**PUBLIC HEARING TO CONSIDER THE PROPOSED “LEV II” AND “CAP 2000”
AMENDMENTS TO THE CALIFORNIA EXHAUST AND EVAPORATIVE EMISSION
STANDARDS AND TEST PROCEDURES FOR PASSENGER CARS, LIGHT-DUTY
TRUCKS AND MEDIUM-DUTY VEHICLES, AND TO THE EVAPORATIVE
EMISSION REQUIREMENTS FOR HEAVY-DUTY VEHICLES**

Staff’s Suggested Changes to the Original Proposal

PRESENTED AT THE NOVEMBER 5, 1998 HEARING OF THE AIR RESOURCES BOARD

Figure 3A: Test Procedure for 2003 and Subsequent Hybrid Electric Vehicles

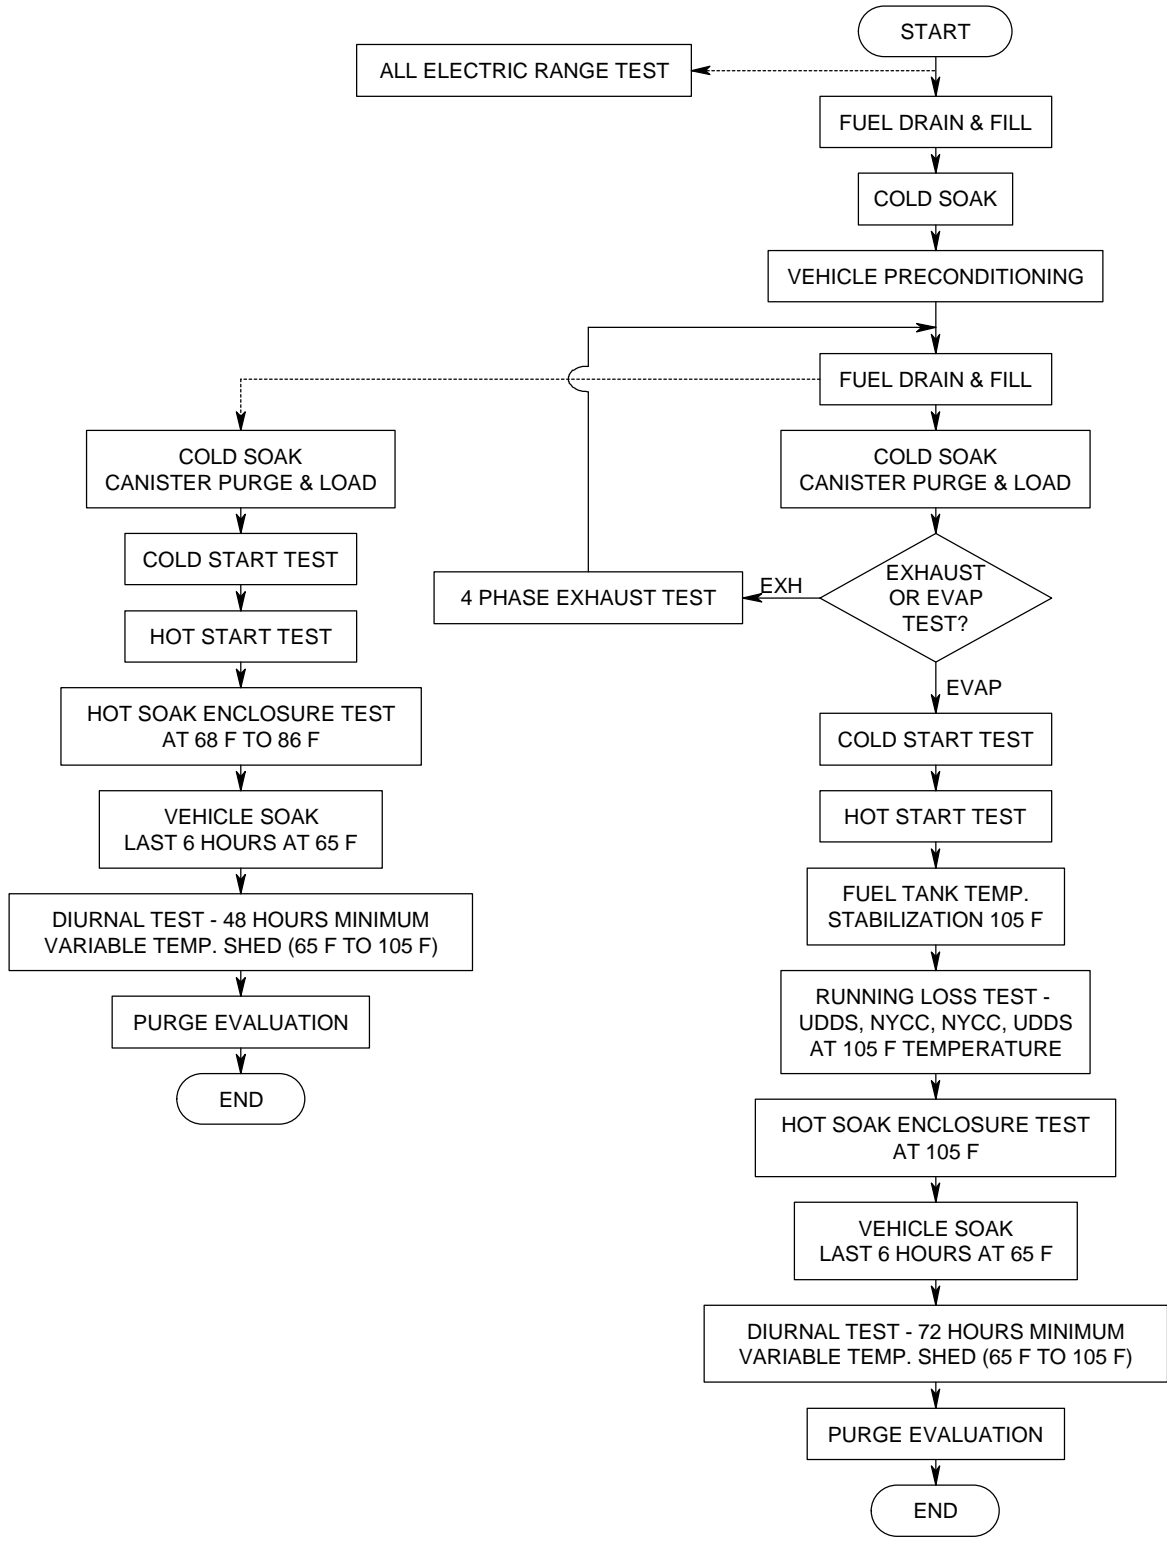
1.7.1 For hybrid electric vehicles, a four phase exhaust test shall be performed as shown in Figure 3A pursuant to the “California Zero-Emission and Hybrid Electric Vehicle Exhaust Emission Standards and Test Procedures for 2003 and Subsequent Model Passenger Cars, Light-Duty Trucks, and Medium-Duty Vehicles” as incorporated by reference herein. Following the four phase exhaust test, the test sequence shall repeat from step 1.3 of this section to conduct the evaporative test using the standard cold start test and hot start test (standard three phase test) without emission sampling. Battery state-of-charge setting prior to the standard three phase test shall be performed pursuant to section 6.1.6 of the “California Zero-Emission and Hybrid Electric Vehicle Exhaust Emission Standards and Test Procedures for 2003 and Subsequent Model Passenger Cars, Light-Duty Trucks, and Medium-Duty Vehicles” as incorporated by reference herein. Four phase exhaust testing may be performed in conjunction with evaporative testing as shown in Figure 3B with advance Executive Order approval if the manufacturer is able to provide data demonstrating compliance with evaporative testing using the standard three phase test.

This text would be added to retain evaporative emission testing stringency by separating the four phase hybrid electric vehicle exhaust emission test from the evaporative emission test that requires a three phase test.

Figure 3B: Test Procedure for 2003 and Subsequent Hybrid Electric Vehicles

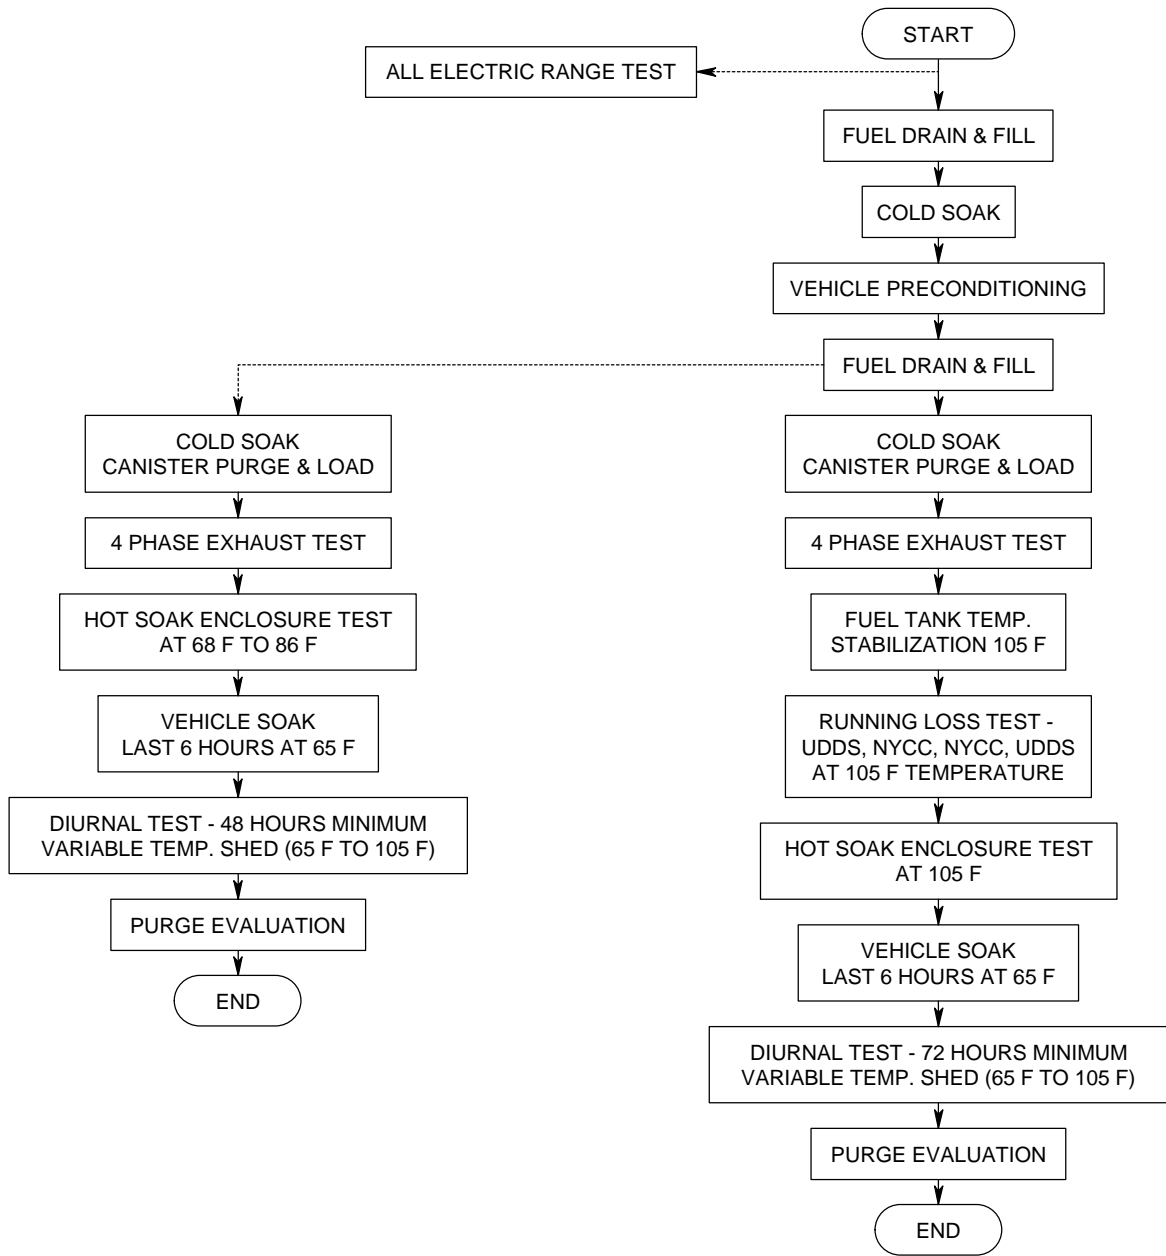
The test sequence shown in Figure 2 (Figure 3A or 3B for hybrid electric vehicles) describes the steps encountered as the vehicle undergoes the three-day diurnal sequence and the supplemental two-day diurnal sequence to determine conformity with the standards set forth. Methanol measurements may be omitted when methanol-fueled vehicles will not be tested in the evaporative enclosure. Ambient temperature levels encountered by the test vehicle throughout the entire duration of this test sequence shall not be less than 68°F nor more than 86°F, unless otherwise specified. The temperatures monitored during testing shall be representative of those experienced by the test vehicle. The test vehicle shall be approximately level during all phases of the test sequence to prevent abnormal fuel distribution. The temperature tolerance of a soak period may be waived for up to 10 minutes to allow purging of the enclosure or transporting the vehicle into the enclosure.

The three-day diurnal test sequence shown in Figure 2 (and Figure 3A or 3B for hybrid electric vehicles) is briefly described as follows:

This modification clarifies the originally proposed text.
